SUBSURFACE WASTEWATER DISPOSAL SYSTEM APPLICATION

Street or Road: 77 OUTLET ROAD

9/8/04 Amending permit #5320

REPLACEMENT SYSTEM VARIANCE REQUEST

SITE PLAN

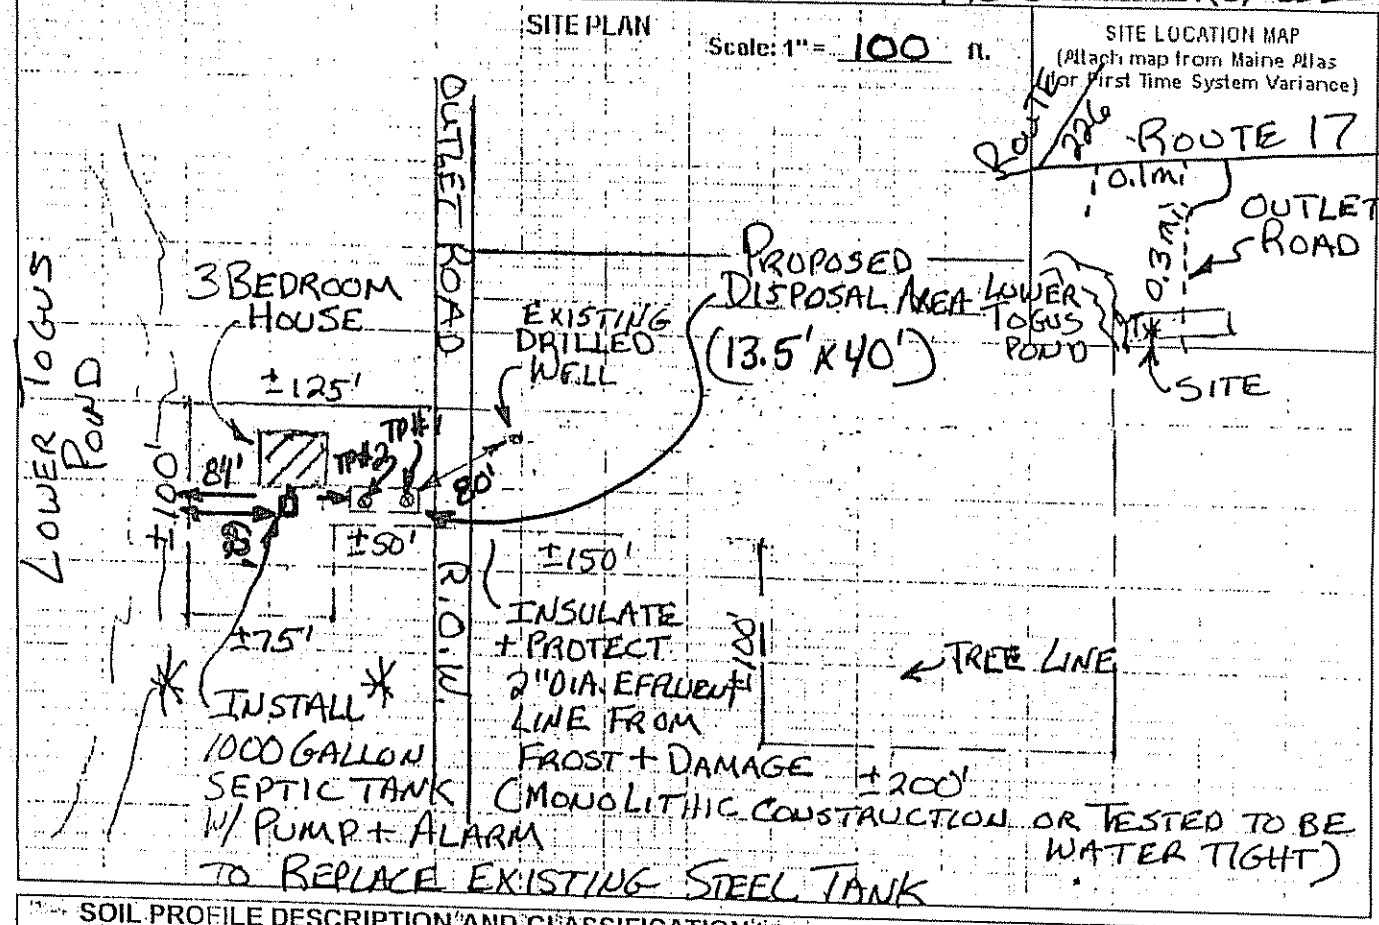
Soil Profile	Classification Condition	Slope Percent	Limiting Factor Depth	
8	D	3	10	☒ Groundwater ☐ Restrictive Layer ☐ Bedrock

Soil Profile	Classification Condition	Slope Percent	Limiting Factor Depth	
8	D	5	13	☒ Groundwater ☐ Restrictive Layer ☐ Bedrock

SUBSURFACE WASTEWATER DISPOSAL PLAN

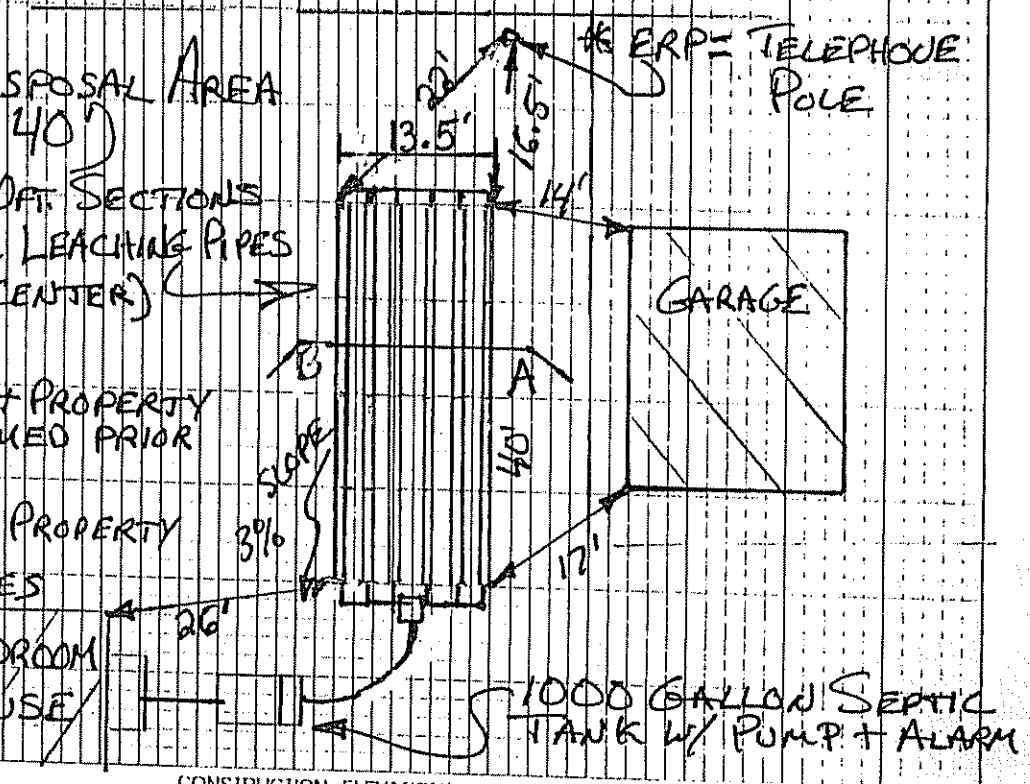
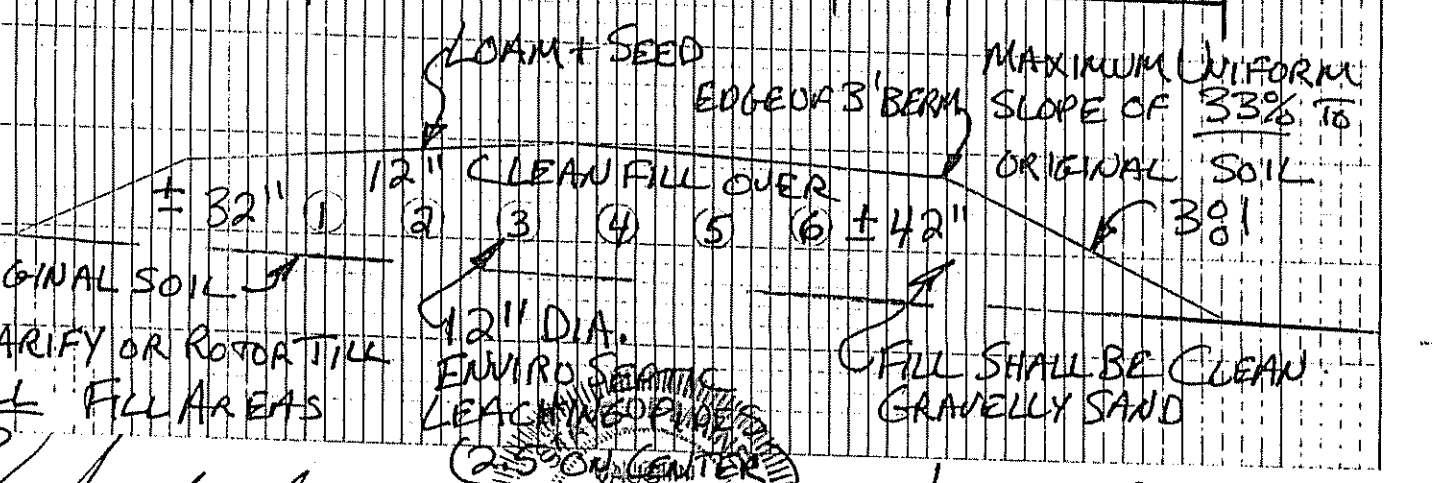
- [ ] 1. Stone Bed
- [ ] 2. Stone Trench
- [X] 3. Proprietary Device
  - [ ] a. cluster array
  - [ ] c. Linear
  - [X] b. regular load
  - [ ] d. H-20 load
- [ ] 4. Other: EZ MRO SEPTICS

PROFILE: B / CONDITION: D / DESIGN: _____

Depth 10"

Depth of Fill (Upslope) 32"

Depth of Fill (Downslope) 42"

Location & Description TELEPHONE POLE W/NAIL 44" ABOVE GROUND
